G2 Alternator

**Alternator**

Shown on engine 111.951
in model 203.035

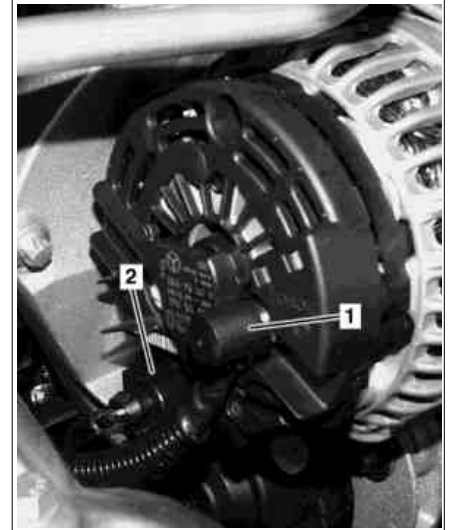
14.4.00	Value changed from 15 Nm to 18 Nm	Figure in BA15.40-P-1001-01A for engine 112, 113 modified	*BA15.40-P-1001-01A
14.4.00	Value changed from 4 Nm to 5 Nm	Specification in BA15.40-P-1002-01A revised for 112, 113 engines	*BA15.40-P-1002-01A

Number	Designation		Engine 111	Engine 112.91/92/94/ 953/954/955/ 96/97 except 112.976, engine 113.94/96/98
BA15.40-P-1001-01A	Nut, circuit B+ to alternator	Nm	15	18
BA15.40-P-1002-01A	Nut, circuit D+ to alternator	Nm	4	5
BA15.40-P-1003-01A	Alternator bolt	Nm	42	42
